LTR-NRC-12-67  
September 19, 2012

Subject: Resolution of Open Items from NRC Audit on WCAP-16182-P-A, Revision 1, "Westinghouse BWR Control Rod CR 99 Licensing Report – Update to Mechanical Design Limits" (Proprietary/Non-Proprietary)

**Resolution of Open Items from NRC Audit on WCAP-16182-P-A, Revision 1,  
“Westinghouse BWR Control Rod CR 99 Licensing Report – Update to Mechanical Design Limits”  
(Non-Proprietary)**

Figure 13 [

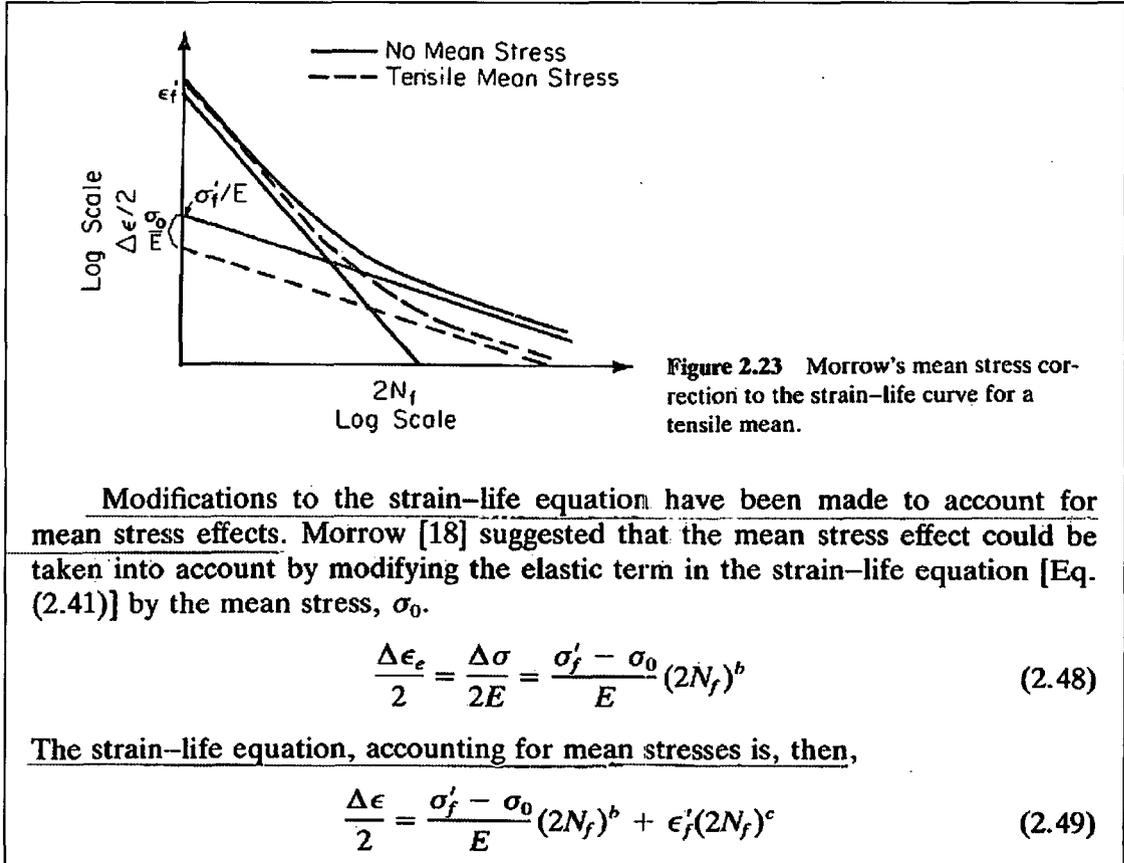
Explain that bending stresses due to seismic events are covered by the experimental testing and not included in the analysis. Provide the bending stress results comparing CR99 to CR85 to show that the experimental data from the CR85 testing is valid for the CR99.

The number of cycles during a seismic event would be very few. This means that if the control rod is damaged, [
